SUBJECT: BEAVER VALLEY POWER STATION, UNITS 1 AND 2 - STAFF ASSESSMENT OF INFORMATION PROVIDED PURSUANT TO TITLE 10 OF THE *CODE OF FEDERAL REGULATIONS* PART 50, SECTION 50.54(f), SEISMIC HAZARD REEVALUATIONS FOR RECOMMENDATION 2.1 OF THE NEAR-TERM TASK FORCE REVIEW OF INSIGHTS FROM THE FUKUSHIMA DAI-ICHI ACCIDENT (TAC NOS. MF3726 AND MF3727)

STAFF ASSESSMENT BY THE OFFICE OF NUCLEAR REACTOR REGULATION

RELATED TO SEISMIC HAZARD AND SCREENING REPORT

BEAVER VALLEY POWER STATION, UNITS 1 AND 2

Figure 3.3-1: Plot of Staff's and Licensee's Base Case Shear-Wave Velocity Profiles for the Beaver Valley site

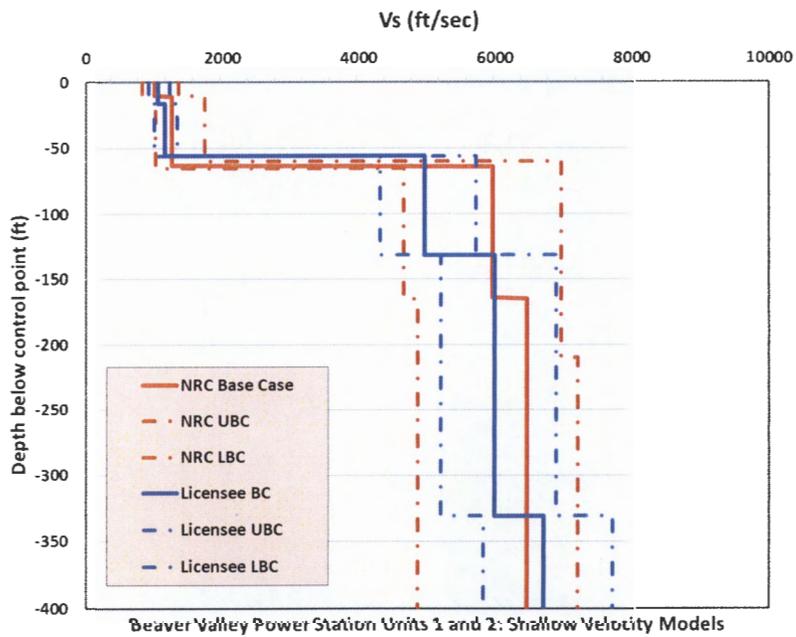
To capture the uncertainty in the shear wave velocities beneath the plant, the licensee developed three base-case shear-wave velocities for the Beaver Valley site. The licensee used a scale factor of 1.15 relative to the preferred base case model to calculate the lower and upper base case shear-wave velocity profiles. The licensee utilized sonic log information obtained from nearby oil and gas exploration wells in the vicinity of the Beaver Valley site to constrain the middle or best base case profile and provide insights on the variability in shear-wave velocity with depth. Figure 3.3-1 of this assessment shows the licensee's three shear-wave velocity base case profiles.

To capture the uncertainty in the subsurface shear wave velocity, the NRC staff developed three base case velocity profiles. For the middle or best estimate velocity profile, the NRC staff based the upper portion of its velocity profile on the information contained in the UFSARs for Units 1 and 2 (FENOC, 2011 and 2012). The UFSARs contain direct shear-wave velocity measurements within the Upper Terrace deposits, as well as within the upper most portion of the underlying Allegheny Group shales. To estimate the shear wave velocities for the deeper rock layers, the NRC staff used sonic data from the Pennsylvania Department of Conservation and Natural Resources and the Ohio Division of Natural Resources and regional references (Berg, et al., 1980). Observations of lithologic units in the region show that the rock are generally flat-lying and well correlated over large distances (Miles and Whitfield, 2001). To develop the lower and upper base case velocity profiles, the NRC staff used a natural log standard deviation of 0.25. In addition, to account for uncertainty in the depth to reference or basement rock, the NRC staff randomized the total thickness of each profile by +/-20 percent. The NRC staff velocity profiles are compared to the licensee's in Figure 3.3-1 of this staff assessment. As shown in the figure, the NRC staff and licensee profiles are generally similar over all depth ranges.

Figure 3.3-2 Plot Comparing the Staff's and the Licensee's estimates of kappa for the Beaver Valley site

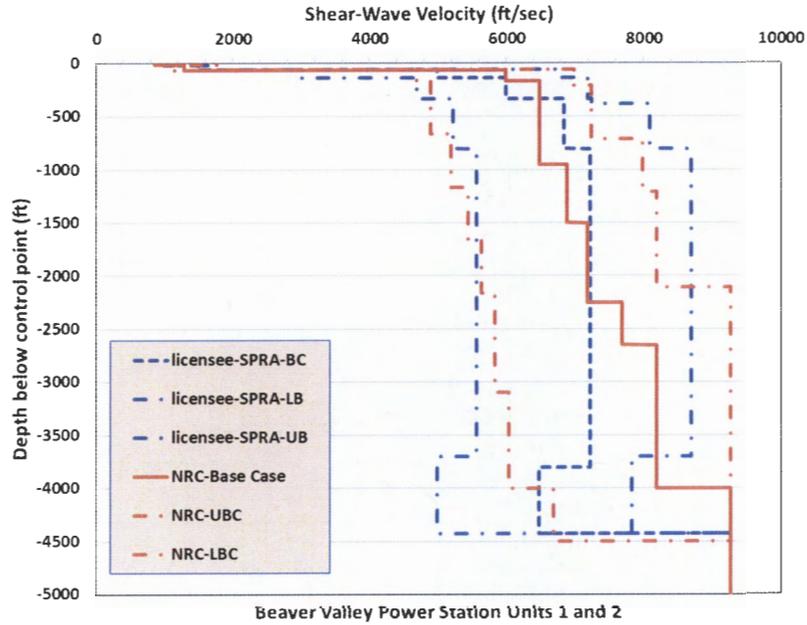
To account for the impact of the site kappa, the NRC staff used the same approach as the licensee. Applying the SPID recommended formula for rock sites with at least 3,000 ft (1000 m) of firm sedimentary rock, the NRC staff first calculated kappa values using the licensee's V_{S100} values (average shear wave velocity over the upper 100 ft of the profile) for each of the three base case velocity profiles. The NRC staff's preliminary verification indicated that the licensee incorrectly calculated kappa for the three profiles since the SPID recommended formula already includes the basement or reference rock contribution. By letter dated June 29, 2015 (Larson, 2015), the licensee provided modified kappa estimates for the Beaver Valley site consistent with the NRC staff's confirmatory calculations. The licensee's modified kappa values for the three profiles are 0.0167 sec, 0.0191 sec, and 0.0146 sec, respectively for the middle, lower and upper profiles. As described above, the licensee augmented the lower and upper kappa values by 50 percent to reflect the uncertainty in this parameter.

In addition, to confirming the licensee's kappa values, the NRC staff also calculated kappa values for its three base case velocity profiles. The NRC staff's kappa values for the middle base-case, lower base-case, and upper base-case are 0.0161, 0.0196, and 0.0136 sec, respectively. To augment the uncertainty in these kappa estimates, the NRC staff applied a natural log standard deviation of 0.25 to calculate a range of kappa for each base-case profile. This approach results in nine kappa values, which were used for the NRC staff's site response analyses. Figure 3.3-2 of this assessment shows a comparison of the licensee's and NRC staff's kappa values. As shown in this figure, the range in kappa assumed by the licensee is greater (especially at larger values) than that applied by the NRC staff.

Figure 3.3-3 Plot Comparing the NRC Staff's and the Licensee's Median Amplification Functions and Uncertainties for two input loading levels for the Beaver Valley site

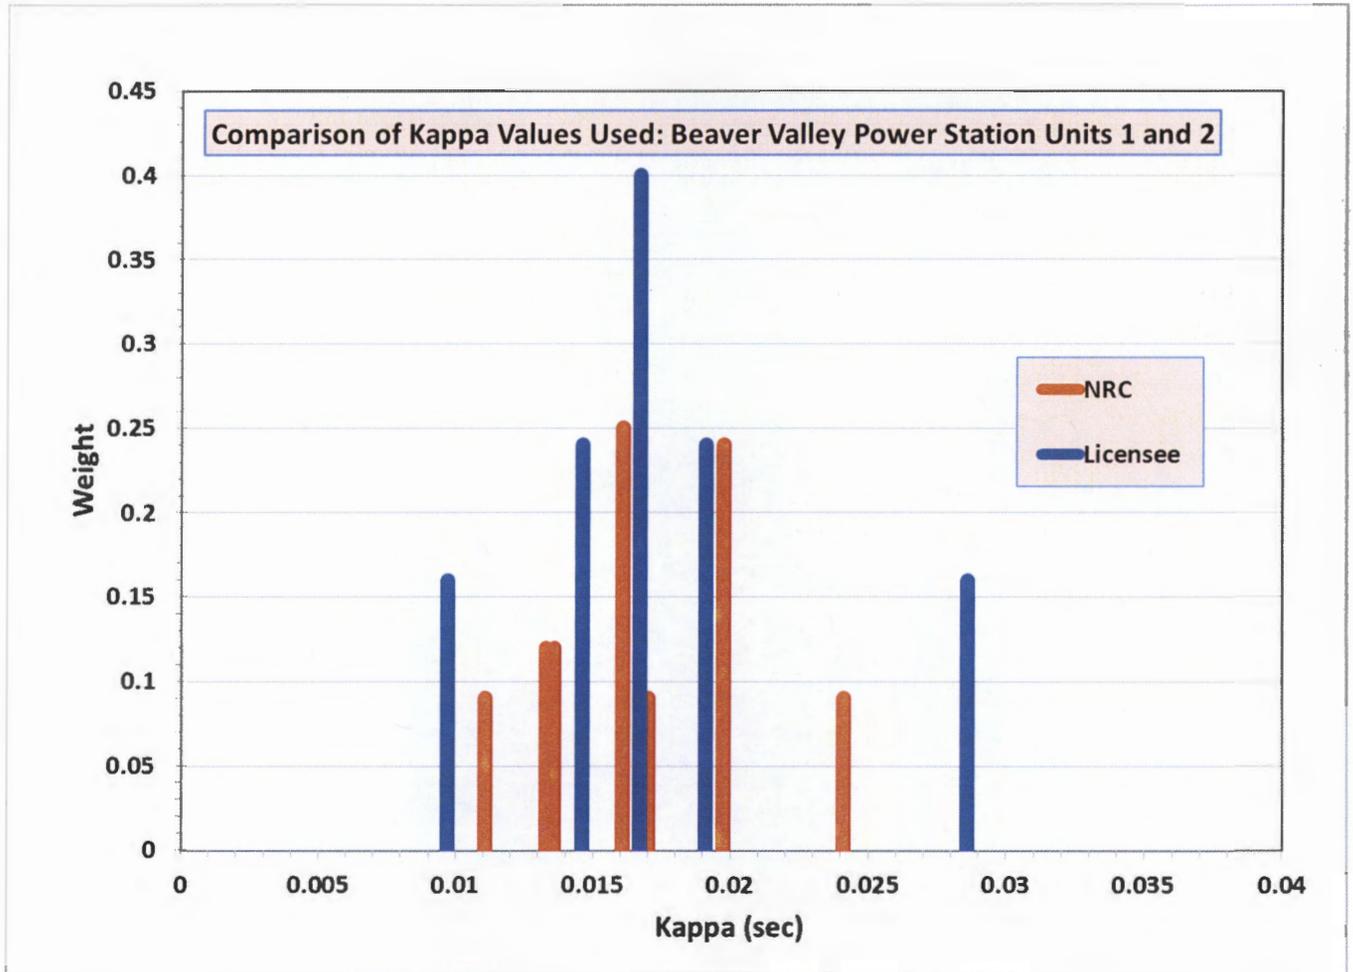
Figure 3.3-3 of this assessment shows a comparison of the amplification functions (median and natural log standard deviation) derived by the NRC staff and by the licensee for two different loading levels. Both the NRC staff and licensee amplification functions peak near 5 Hz. The median amplification functions are generally similar but the peak (absolute value) in the amplification function derived by the licensee is slightly greater than those developed by the NRC staff. As shown in Figure 3.3-4 of this assessment, the NRC staff notes these differences in the site response analysis do not have a large impact on the control point seismic hazard curves between 1 and 10 Hz.

The licensee's and NRC staff's site response analyses produced similar site amplification functions. However, there are some differences in the two approaches with respect to characterizing the uncertainty in kappa, as well as assumptions with respect to modeling the dynamic behavior of the upper soil layers. Appendix B of the SPID provides guidance for performing site response analyses, including capturing the uncertainty for sites with less

Figure 3.3-4 Plot Comparing the Staff's and the Licensee's Mean Control Point Hazard Curves at a Variety of Frequencies for the Beaver Valley site

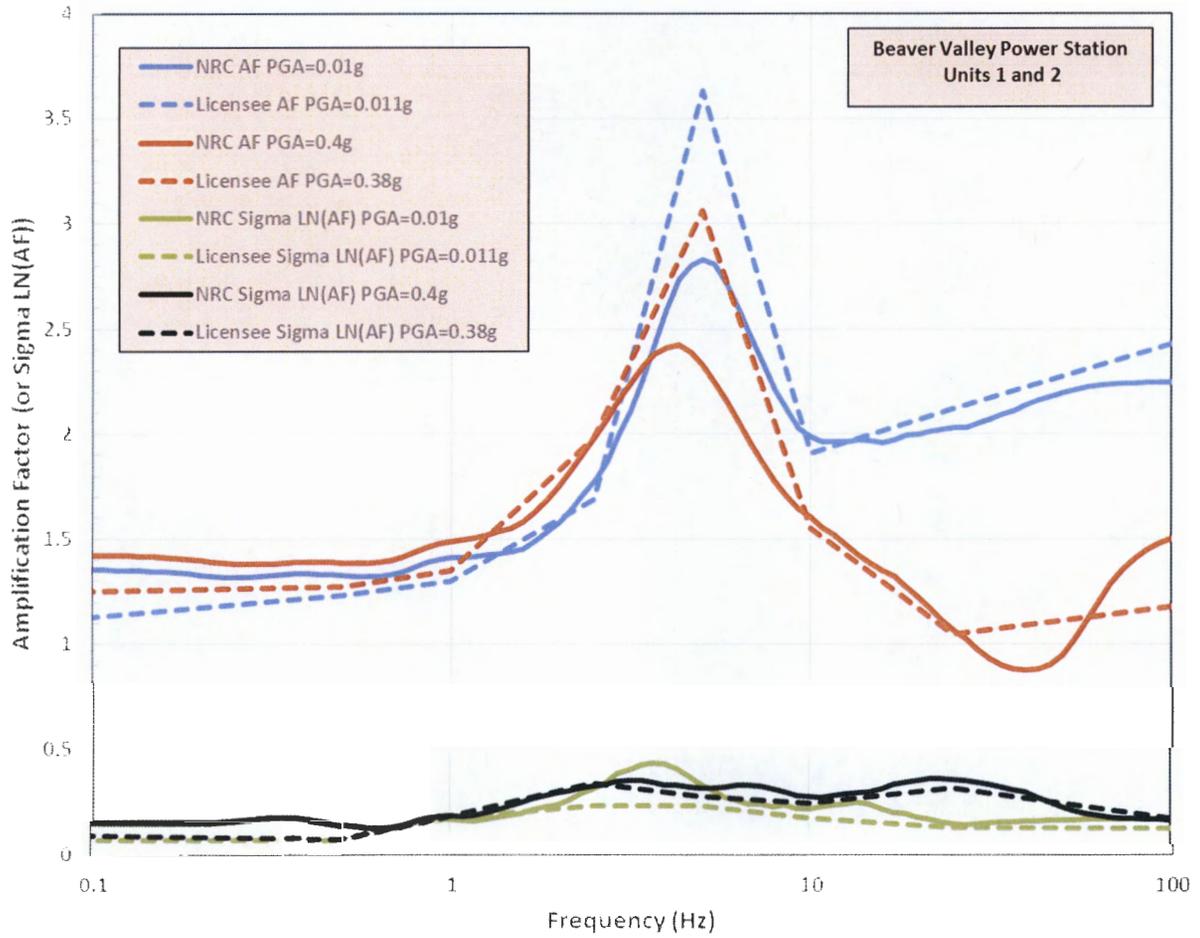
In summary, the NRC staff concludes that the licensee's site response was conducted using present-day guidance and methodology, including the NRC-endorsed SPID. The NRC staff performed independent calculations which confirmed that the licensee's amplification factors and control point hazard curves adequately characterize the site response, including the uncertainty associated with the subsurface material properties, for the Beaver Valley site.

Figure 3.4-1 Comparison of the Staff's GMRS, Licensee's GMRS, and the SSE for the Beaver Valley site

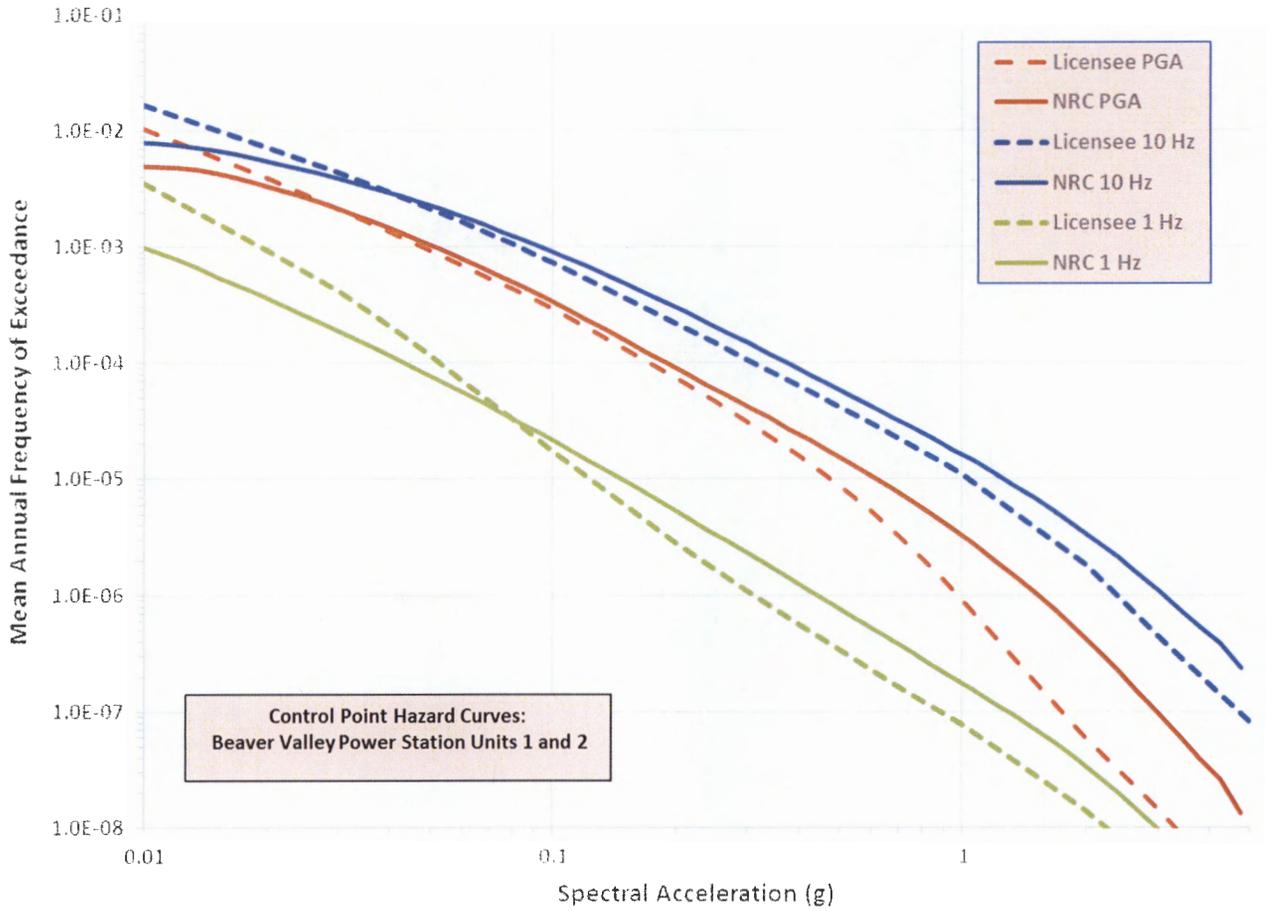
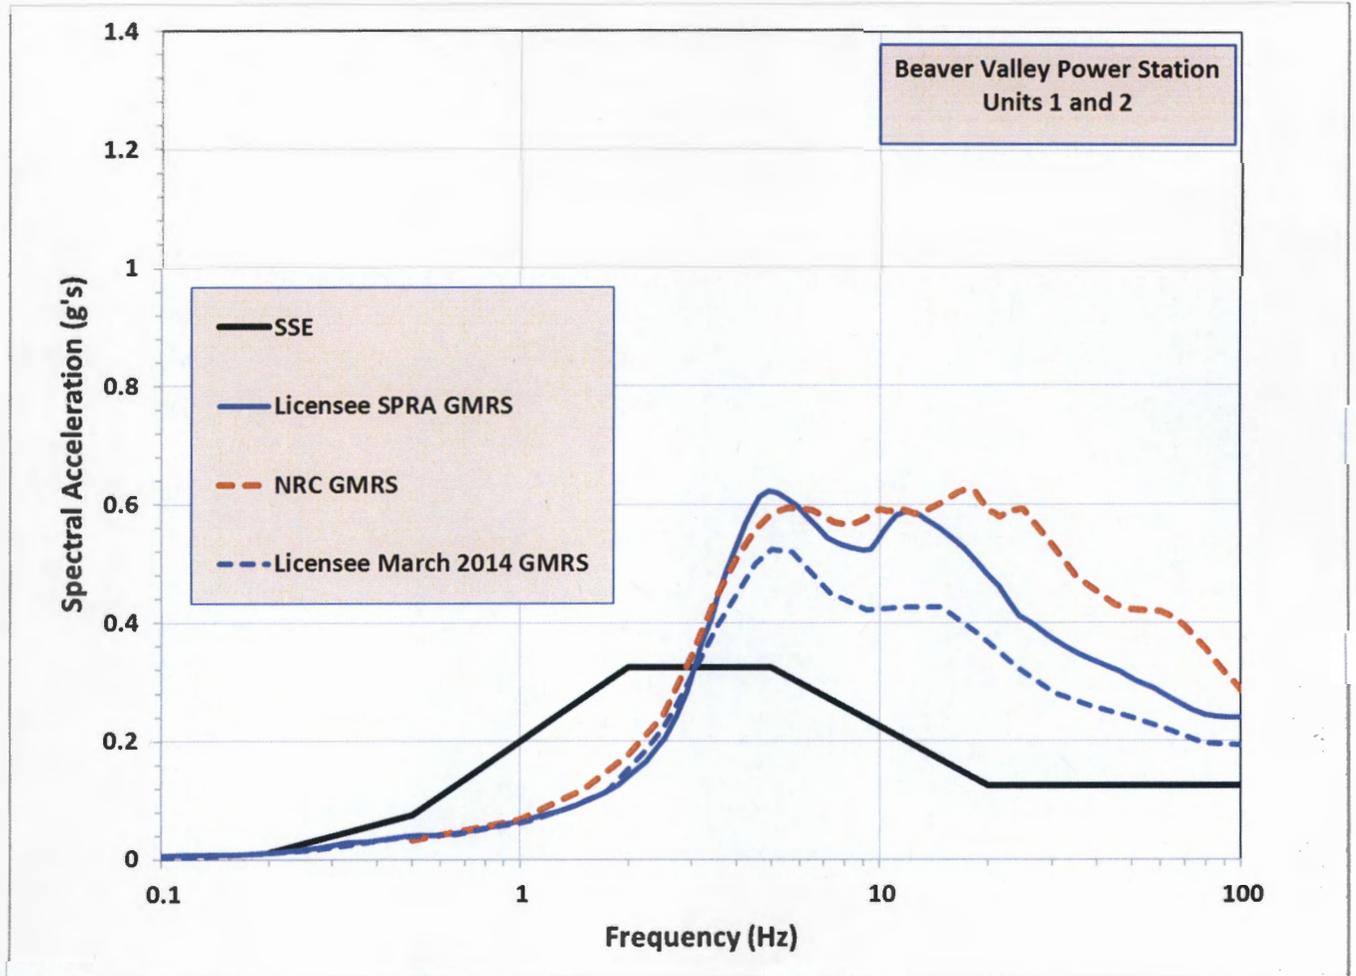
The NRC staff independently calculated the 10^{-4} and 10^{-5} UHRS using the results of its confirmatory PSHA and site response analyses, as described in Sections 3.2 and 3.3 of this staff assessment, respectively. Figure 3.4-1 of this assessment shows a comparison of the initial GMRS determined by the licensee, the licensee's updated GMRS (licensee SPRA GMRS), and the confirmatory GMRS determined by the NRC staff. As shown in Figure 3.4-1, the licensee's updated GMRS is very similar to the NRC staff's confirmatory GMRS for frequencies below 15 Hz. However, the NRC staff's confirmatory GMRS is somewhat higher than the licensee's at frequencies above 15 Hz. The NRC staff concludes these differences arise due to differences between the licensee's and NRC staff's site response analyses, as described above in Section 3.3. The NRC staff concludes that the small differences between the two GMRS are acceptable for this application because the spectral shapes are very similar and the differences are confined to frequencies above 15 Hz for the Beaver Valley site.

Based on the assessment of the licensee's SHSR and the additional information provided in the June 29, 2015, letter (Larson, 2015), the NRC staff confirms that the licensee used the present-day guidance and methodology outlined in RG 1.208 and the SPID to calculate the horizontal GMRS, as requested in the 50.54(f) letter. The NRC staff performed both a PSHA and site response confirmatory analysis and achieved results consistent with the licensee's horizontal GMRS. As such, the NRC staff concludes that the GMRS determined by the licensee adequately characterizes the reevaluated hazard for the Beaver Valley site. Therefore, this GMRS is suitable for use in subsequent evaluations and confirmations, as needed, for the response to the 50.54(f) letter.
